KENDALL BAY REMEDIATION PROJECT

RAP ADDENDUM

Final | 22 June 2018

Kendall Bay Remediation Project for Jemena Limited

Figure 1-1 Suggested Increase to Remediation Sub-Area SA3

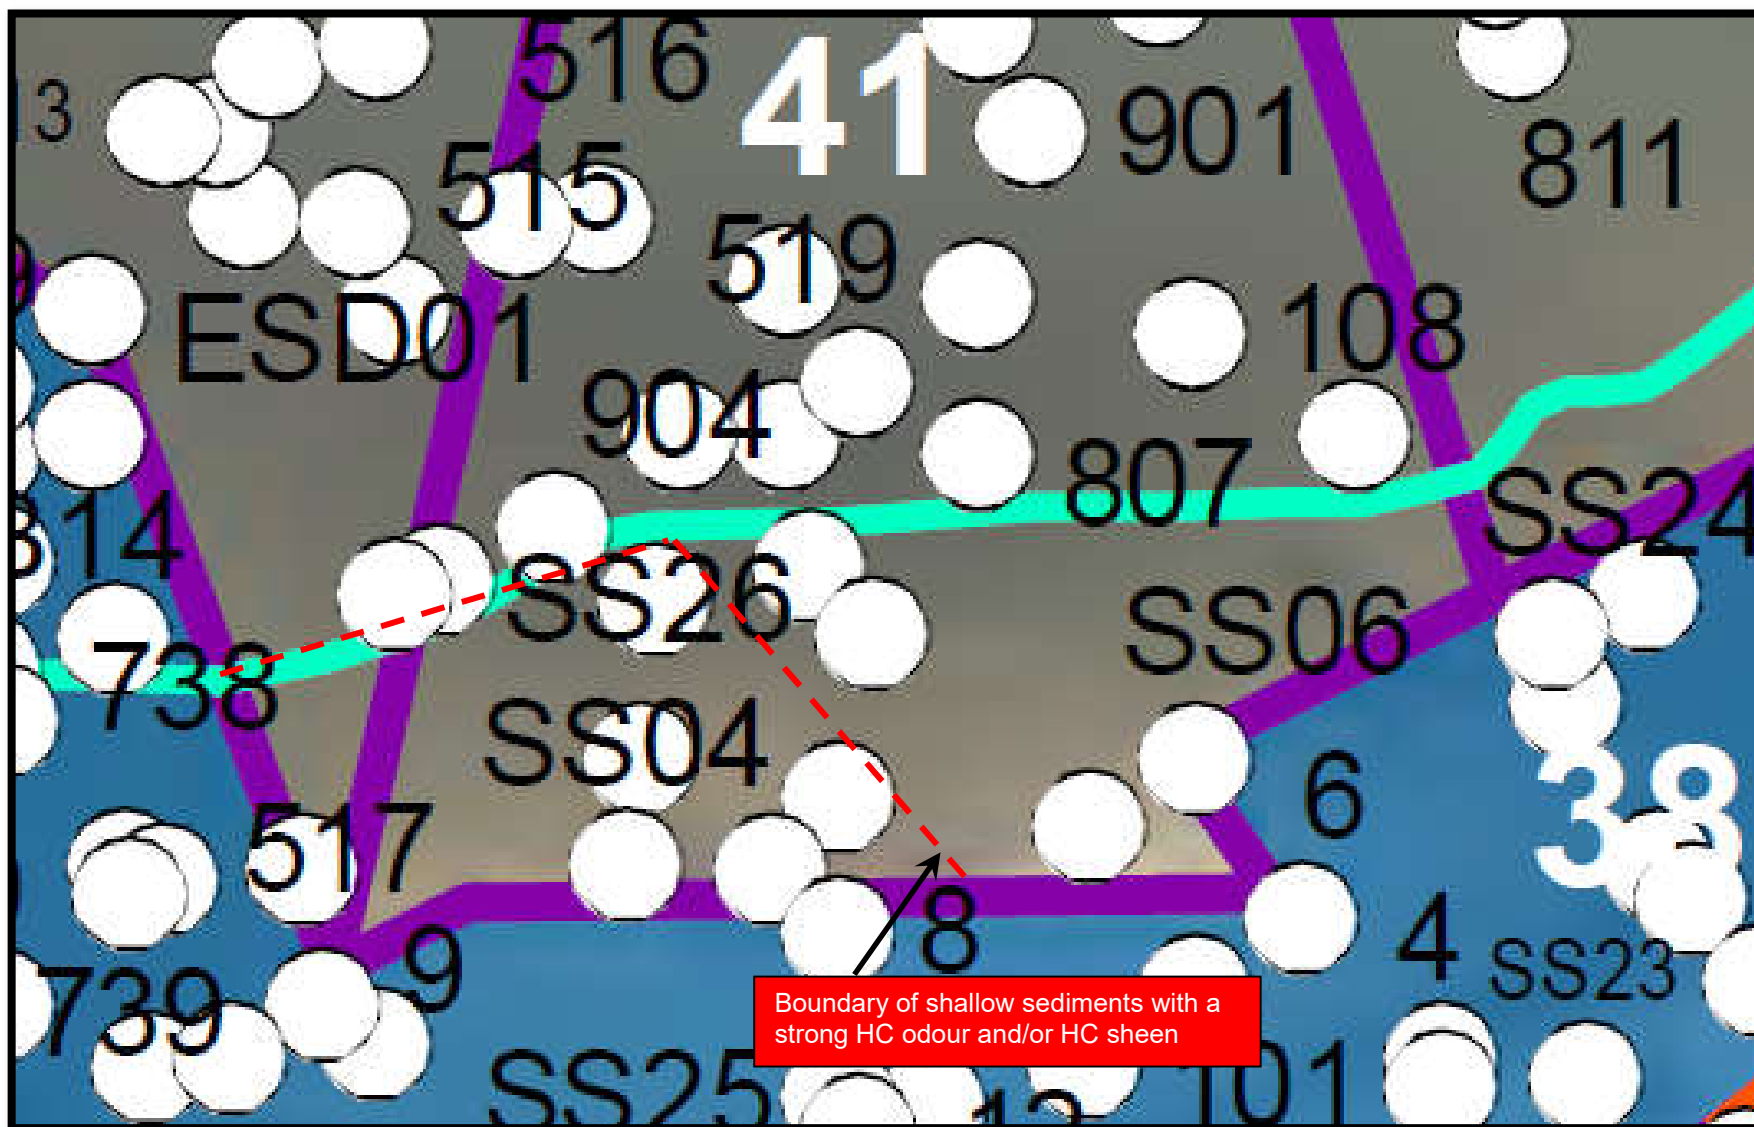
This report considers the part of the Remediation Area in the southern part of Kendall Bay should be slightly modified by moving the north-western boundary of remediation sub-area SA3 to include the south-western corner of Cell 41, as shown in **Figure 1-1**. Such an approach would result in sample locations SS04, HH2_10, B8, B11 and SHA15 being included in the Remediation Area. Such a change would:

- Increase the southern Remediation Area by 2,230 m², consisting of a 1,930 m² area from the southern part of cell 41 and a 300 m² area from the southern part of cell 39;

- Address the health risk exceedance at location SS04 together with aesthetic impacts in this area;
- Provide additional health protection for recreational users of Kendall Bay by addressing uncertainties associated with a transition from a 'source area' exposure scenario at sample location SS04 to a 'beach area' exposure scenario at sample locations HH2_10, B8 and B11;

- Address most of the aesthetic impacts that are located outside the present Remediation Area;
- All sediments in cell 39 would be permanently submerged;

- Provide additional improvements to ecological conditions by reducing the level of total PAH contamination remaining at the southern end of Kendall Bay; and

- Further reduce the mass of PAH contamination that causes the shallow sediments to exceed background PAH levels within the Declared Area.

MNR processes should then be allowed to provide a cover of clean sediment over sediments adjacent to the southern Remediation Area.

Figure 5-3
Exceedances of shallow sediment health criteria
Kendall Bay remediation

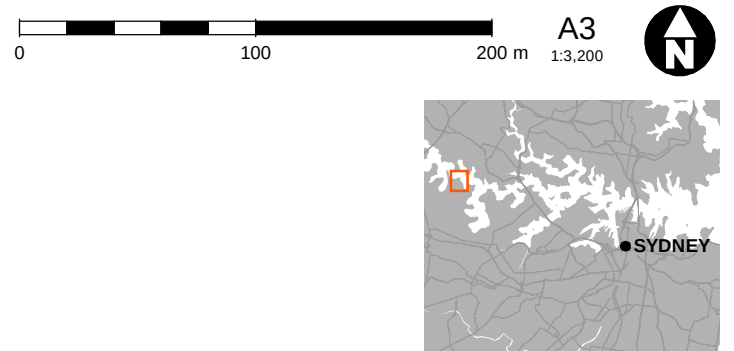
- Practically all sample locations that exceeded the sediment health criteria were located within the Remediation Area proposed by the 2018 RAP, as shown by **Figure 5-3** from the Jacobs report. The only exception is sample location SS04 located close to the SA3 boundary in the western mangrove area. The BaP (TEQ) concentration at this location was measured at 55 mg/kg, which exceeds the health criteria of 1 mg/kg. This health risk could be addressed by either assessing the extent of this exceedance or by slightly moving the SA3 boundary to include this location.

Figure 5-14 Shallow Sediment Descriptions in Cell 41 Tidal Flat Area

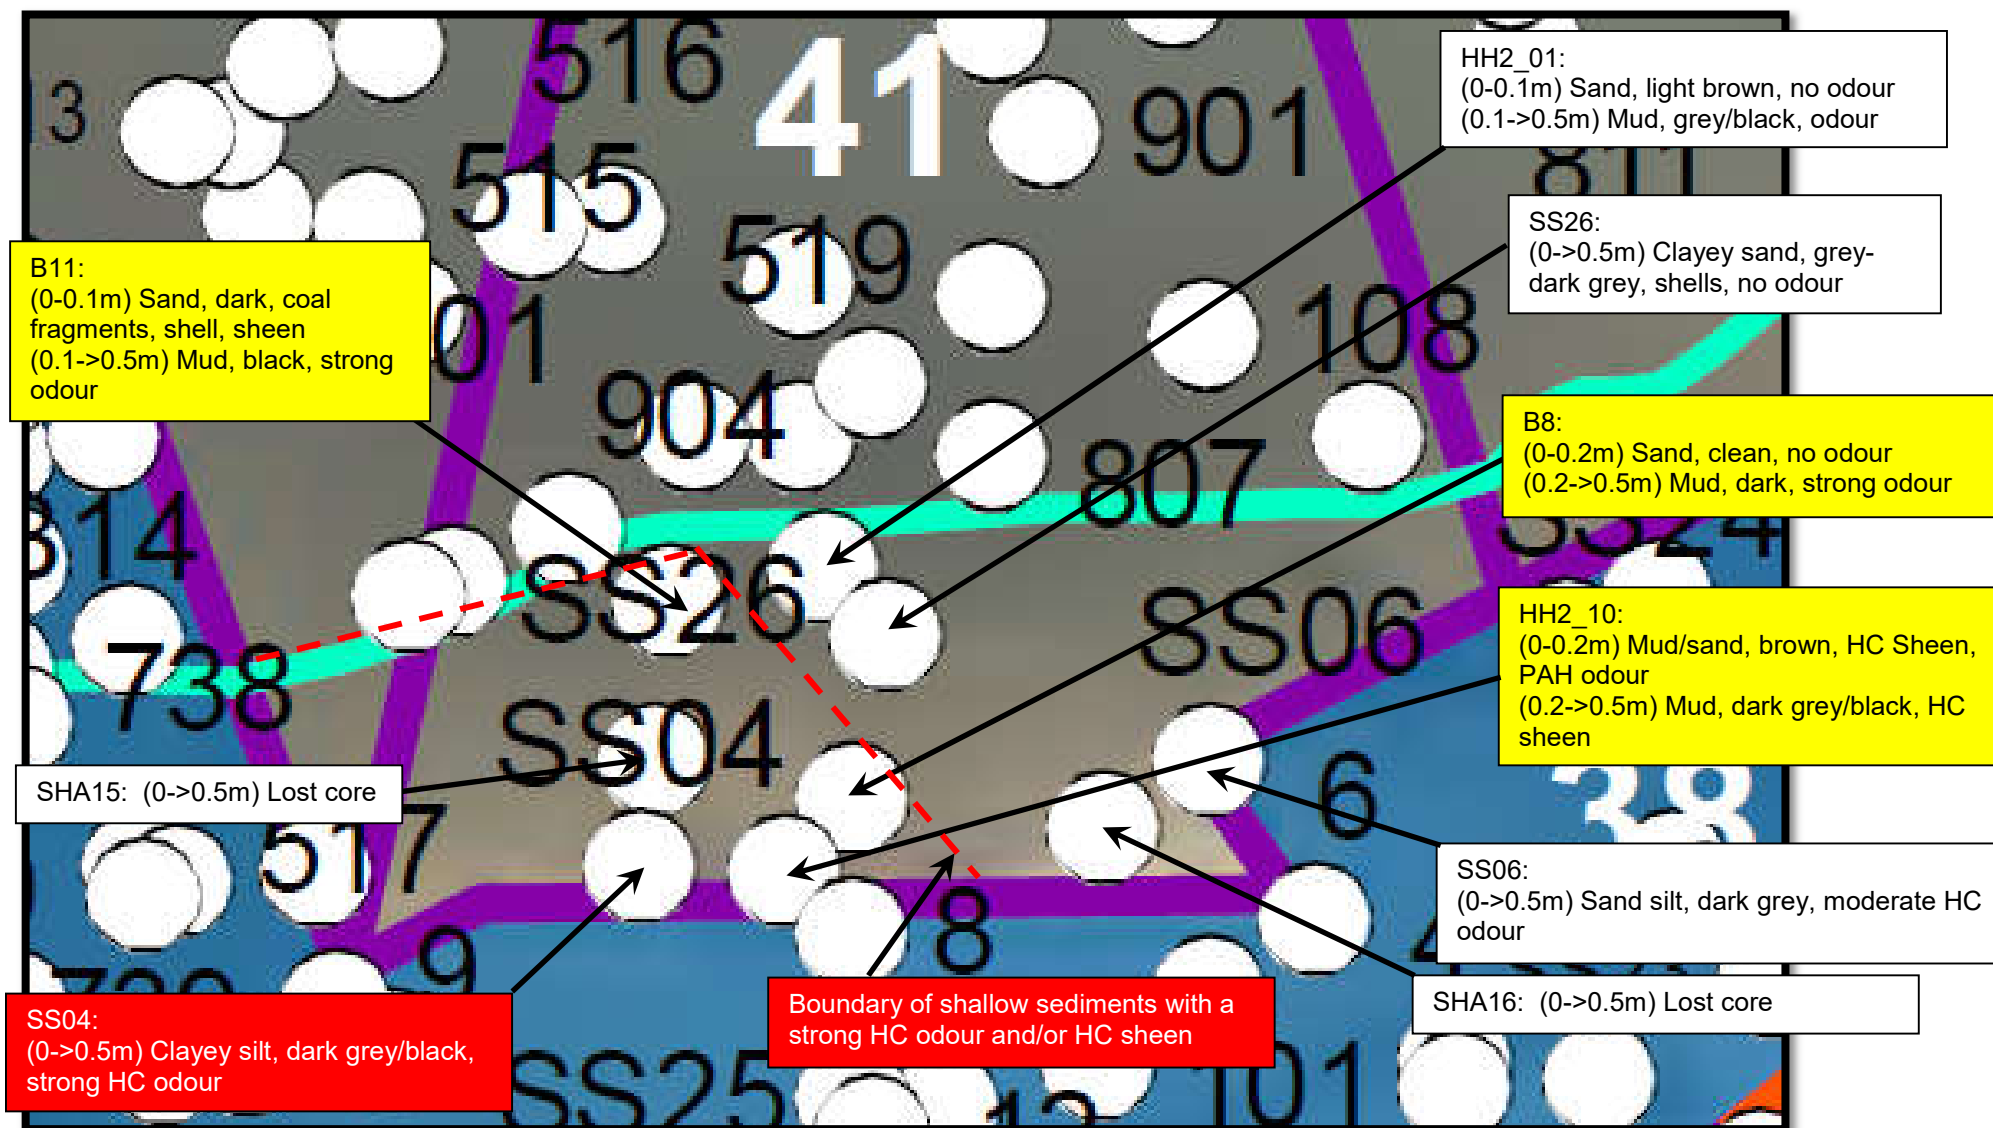
The area north of sub-area SA3 in Cell 41 represents the location where a transition occurs between the 'Source area' and the 'Beach area' exposure scenarios in the southern part of Kendall Bay. **Figure 5-13** shows a detail view of the exposure scenarios assigned to the sample locations in the area. Summary descriptions of the upper 500 mm of sediment in this area are provided in **Figure 5-14**.

The GIS model analysed the aesthetic conditions of the shallow sediment across the Declared Area, with the results summarised in **Figure 5-4**. The analysis showed that the majority of the Declared Area that exceeded the aesthetic criteria is located within the Remediation Area. The exceptions were a few sample locations situated immediately north of sub-area SA3, with a more detailed view of this area provided in **Figure 5-14**.

This report considers the part of the Remediation Area in the southern part of Kendall Bay should be slightly modified by moving the north-western boundary of remediation sub-area SA3 to include the south-western corner of Cell 41, as shown in **Figure 5-14**. Such an approach would result in sample locations SS04, HH2_10, B8, B11 and SHA15 being included in the Remediation Area. Such a change would:

MNR processes should then be allowed to provide a cover of clean sediment over sediments adjacent to the southern Remediation Area.

Figure 5-15: ESD Assessment for Cells Exceeding Average total PAH Ecological Criteria

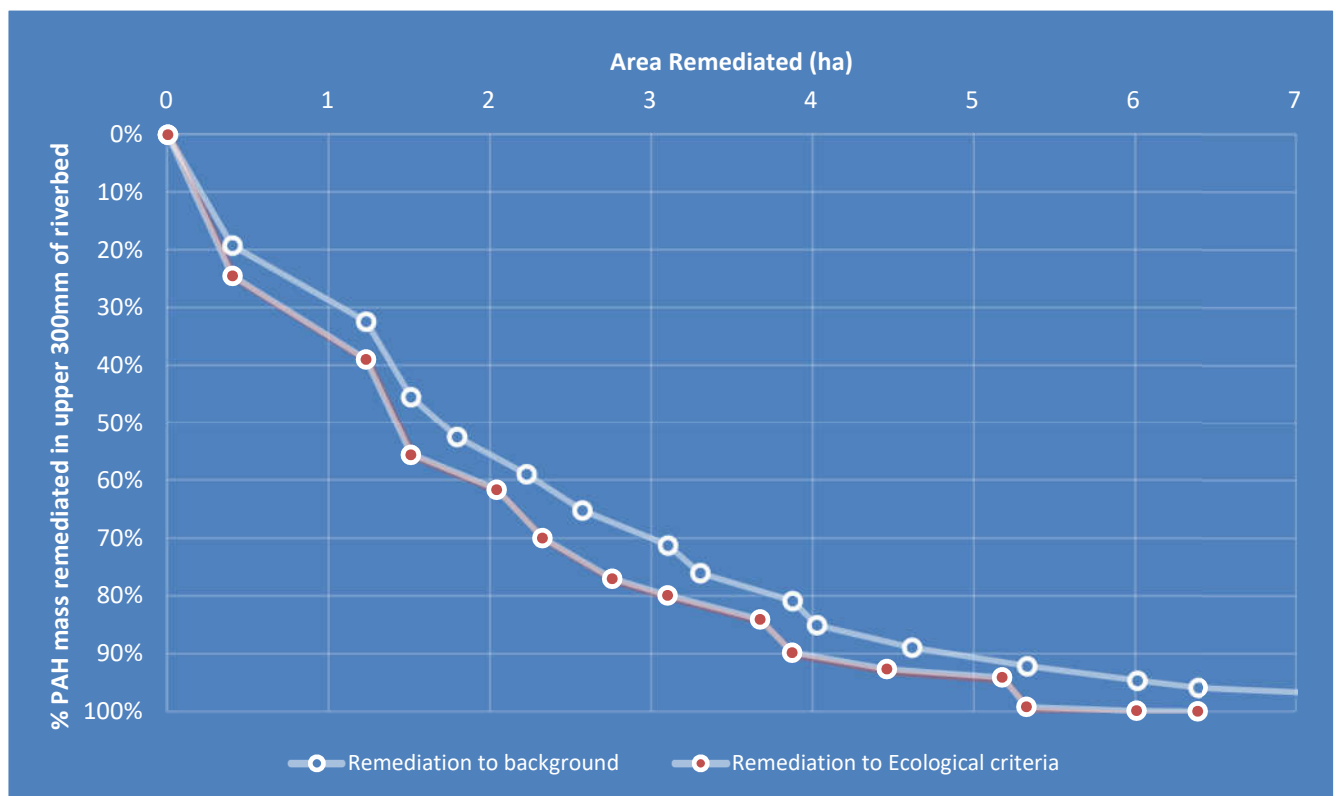
- Represent the part of the Declared Area that would achieve the most effective remediation per unit area in terms of benefits to the ecology, human health and aesthetic impacts. **Figure 5-15** shows the slope of the curve for cells 28 and 38 is steep, with the remediation of the shallow sediments in these two cells also addressing the human health and aesthetic criteria;

Figure 6-1 Cross-Section of Proposed Remediation Strategy for Sub-Area SA1

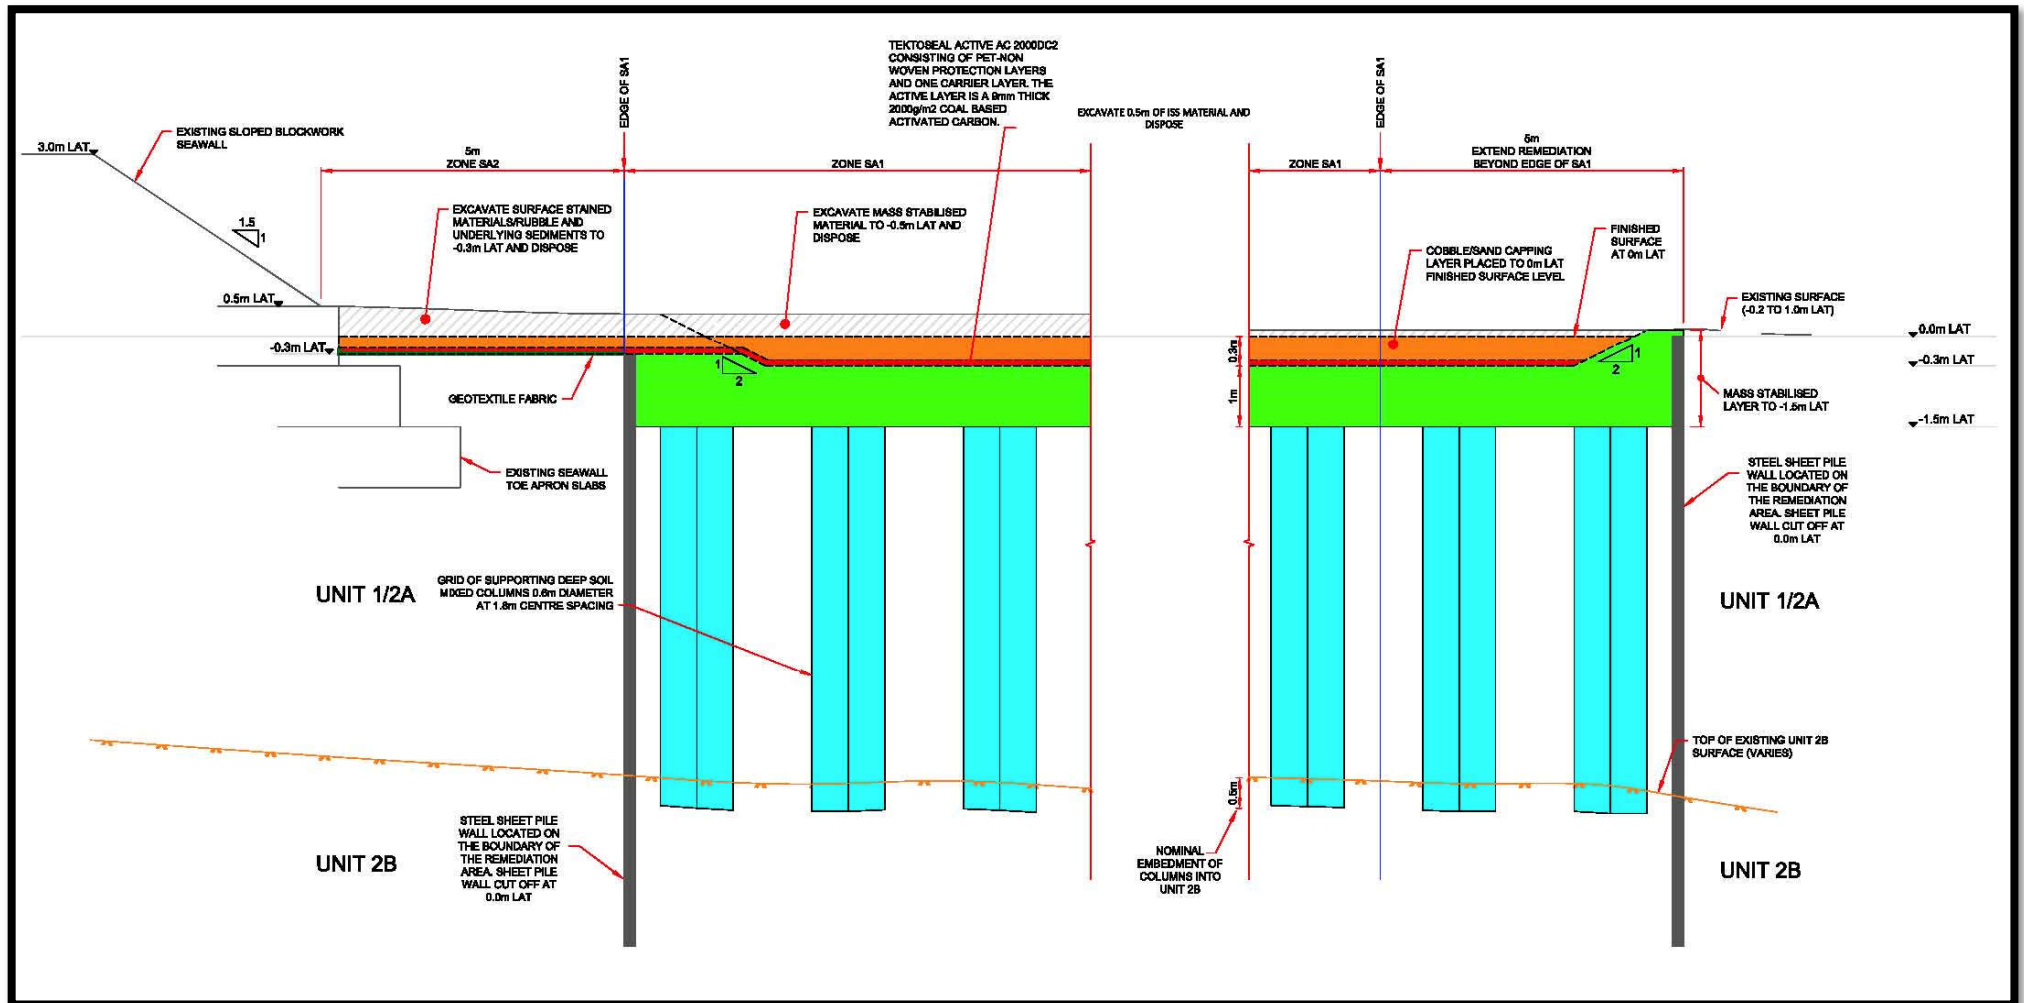
Figure 6-1 provides a cross-section that shows the main design features of this remediation strategy for sub-area SA1, with cross-sections for sub-areas NA2 and NA3 provided in **Figure 6-2**.
